WORKSHOP AGENDA

Planning Commission

September 16, 2025 @ 5:30 PM

UTILITY PLAN
192 AND 198
OLD NASHVILLE HWY

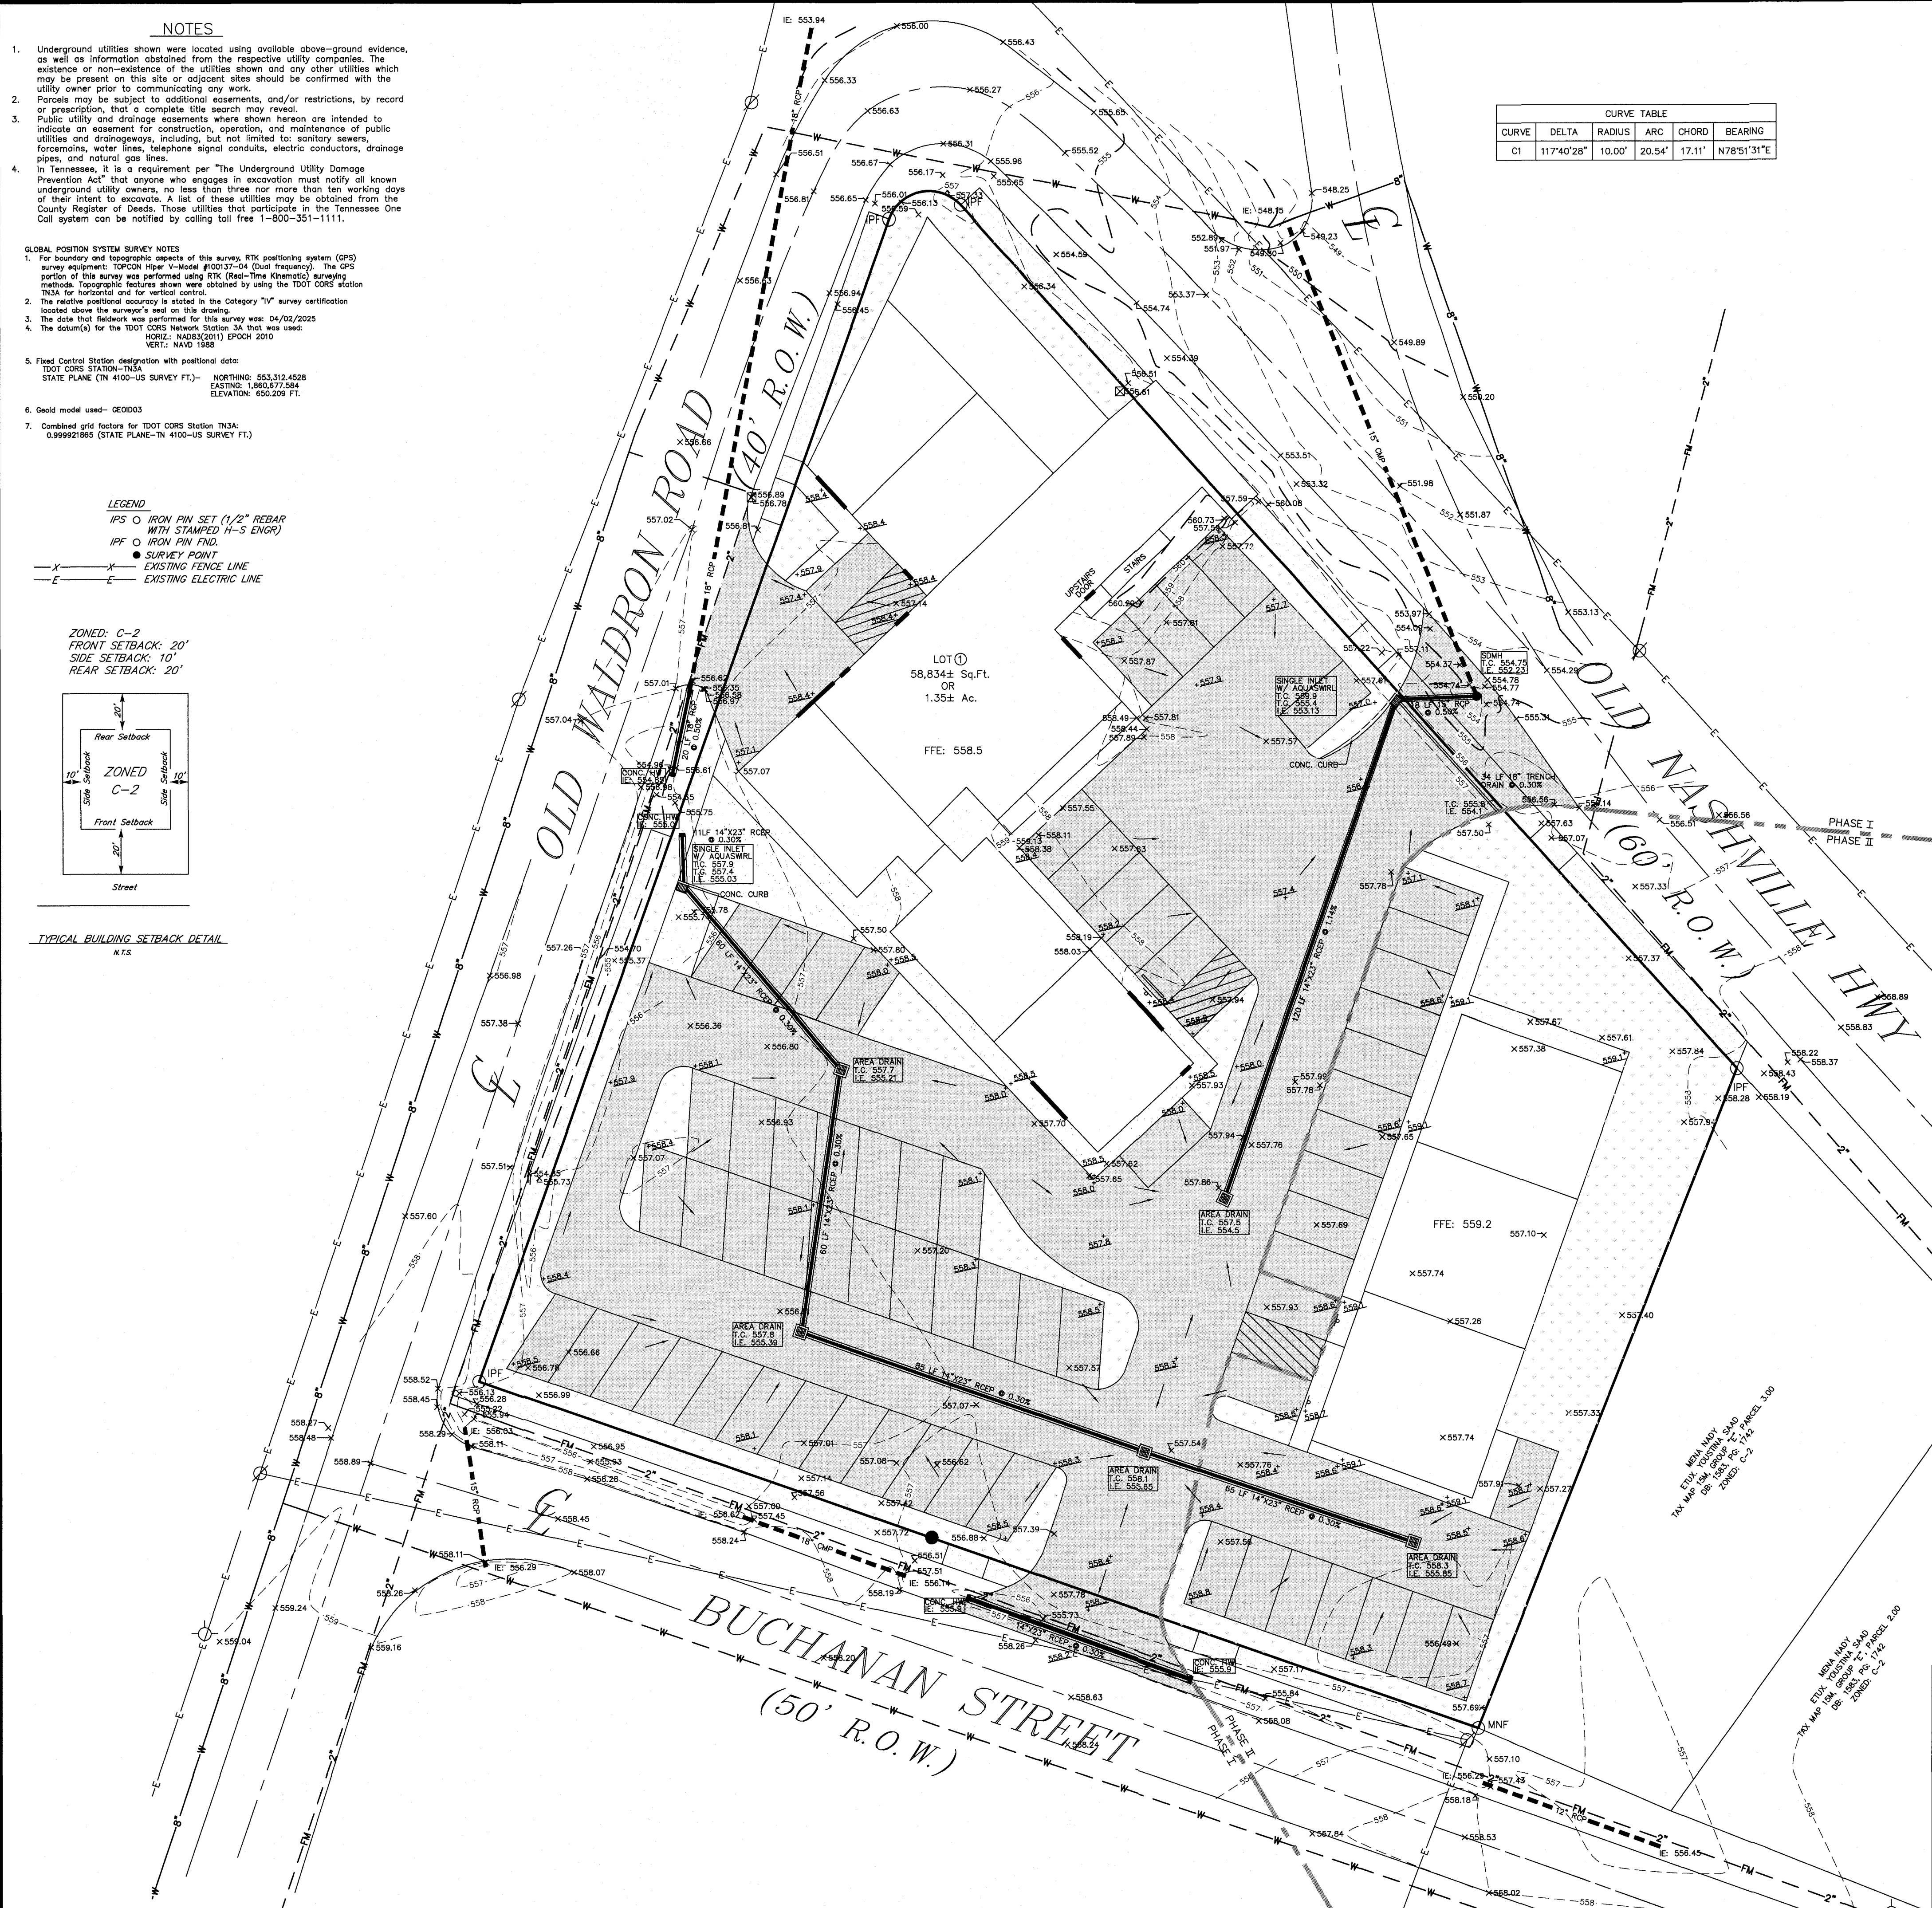
1. Existing 6"W in Buchanan Street is located on the north side of the street (not south as shown).
2. A water meter box is labeled on plans that is actually a terminal sewer cleanout box for the existing 1-1/2" pressure sewer force main located in Old Waldron Rd, west side of 192 Old Nashville.

3. Existing pressure sewer connection box per City Std Dtl 19.0 for existing sewer grinder tank at 192 Old Nashville Hwy is not shown, please locate it on the plans.

5. Per City GIS, there is an existing water meter for a former address of 120 Buchanan St approximately 12 feet due northwest of the existing grinder pump tank of 192 Old Nashville Hwy (west side of property approximately midway north-south). If water meter is still there, then show it on the plan and note to abandon this water meter box and service line at the main.

6. For new building at 192 O.N. Hwy, show sewer service as 1.5" line from existing public low-pressure sewer line in O.N. Hwy to property boundary with a connection box, and note the box as "Pressure Sewer Connection, per City Std Dtl 19.0."

7. Existing public force main in Old Nashville Hwy for proposed building sewer service connection is 1-1/2" pipe (not 2" as noted on plans), according to City records - at the location of the proposed connection.

8. Water in Old Waldron Rd (north south) is along western edge to approximately 2 feet outside of pavement and valves are missing from plans.
9. Please contact Scott Tatalovich, Utility Engineer, statalovich@lavergn.net, C: 615-663-9683, with any questions about water or sewer line locations. Site Plans in City of La Vergne are required to be construction drawings and survey shall include location of all existing surface features such as overhead electrical and water valves, which are missing from these plans.

C-2.1

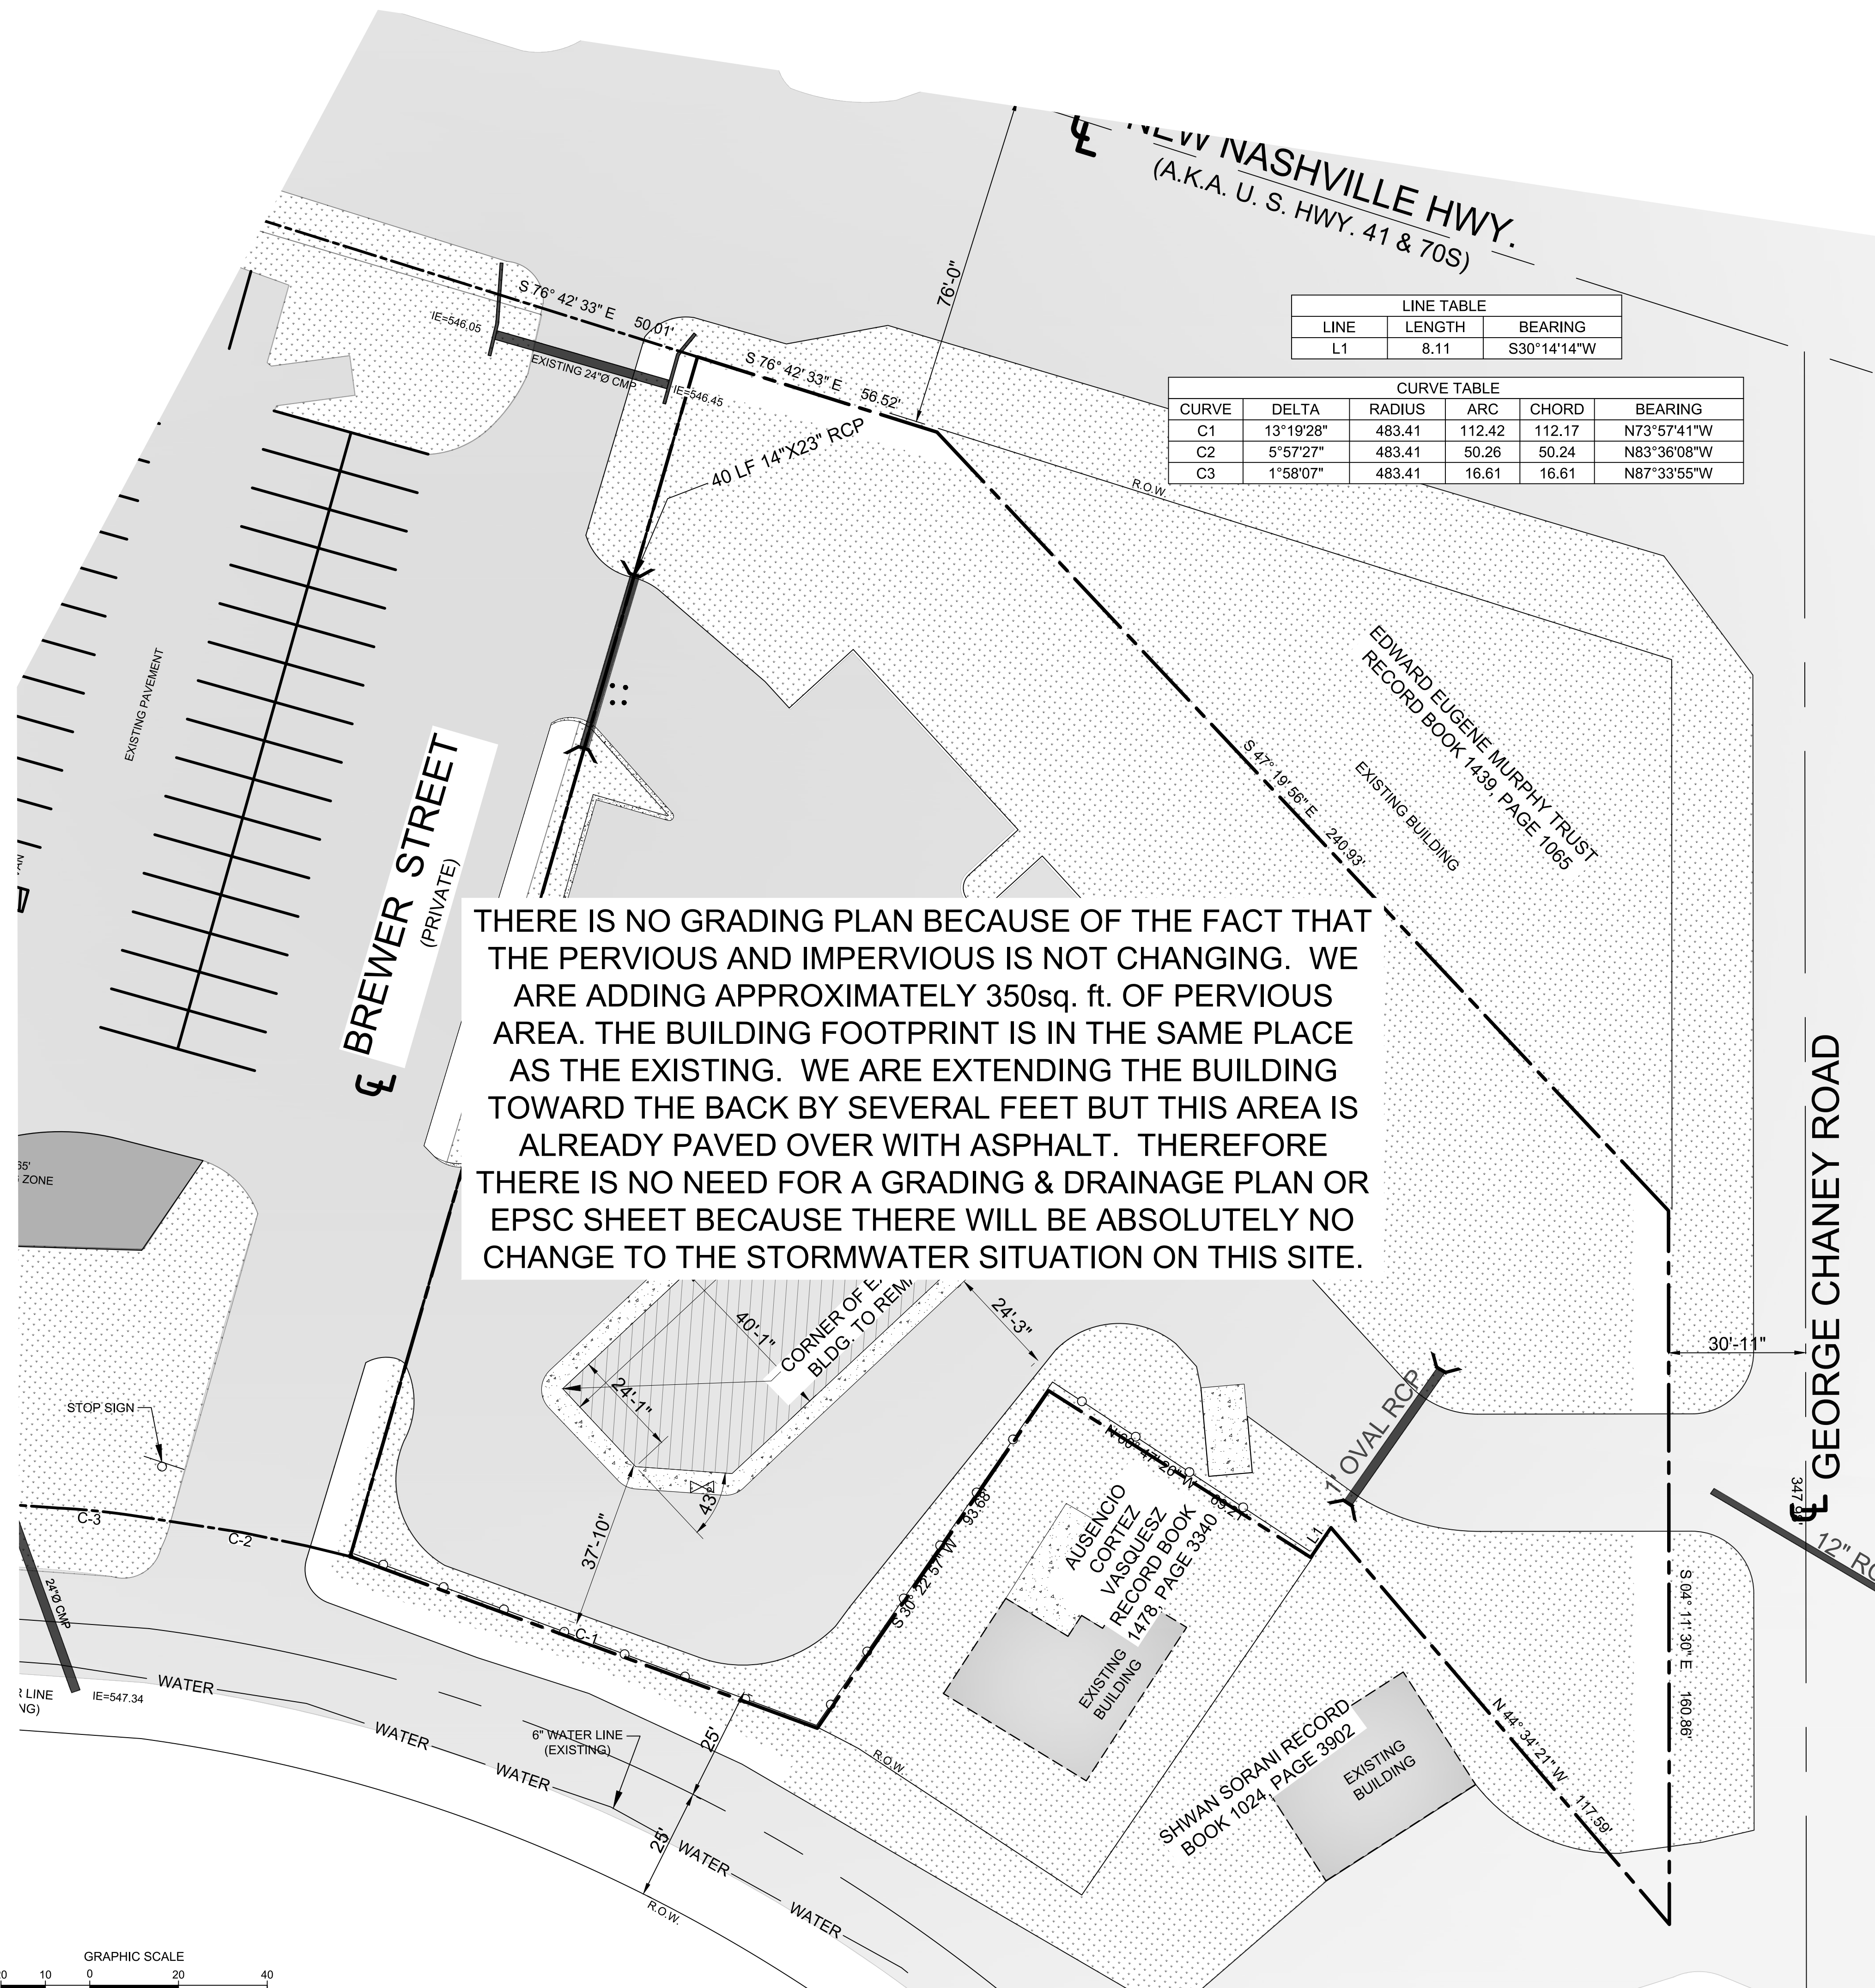
1. (Sheet C-2.1b) Provide a grading and drainage plan showing how site run-off will be handled for the modified structure. Staff does not concur with engineer's statement on the second Sheet C-2.1 that no grading plan is required. The architectural plans show doorways exiting from the proposed portion of the building which will require existing and proposed elevations to confirm IBC and ADA access requirements are met. The grading plan should show, at a minimum:

7. (Sheet C-7.0) The silt fencing shown on the intermediate EPSC plan should be shown on the Initial EPSC Plan (C-7.0).
8. (Sheet C-2.1) It is strongly preferred by staff to connect the proposed walk along Brewer Street with the proposed sidewalk along Murfreesboro Road.
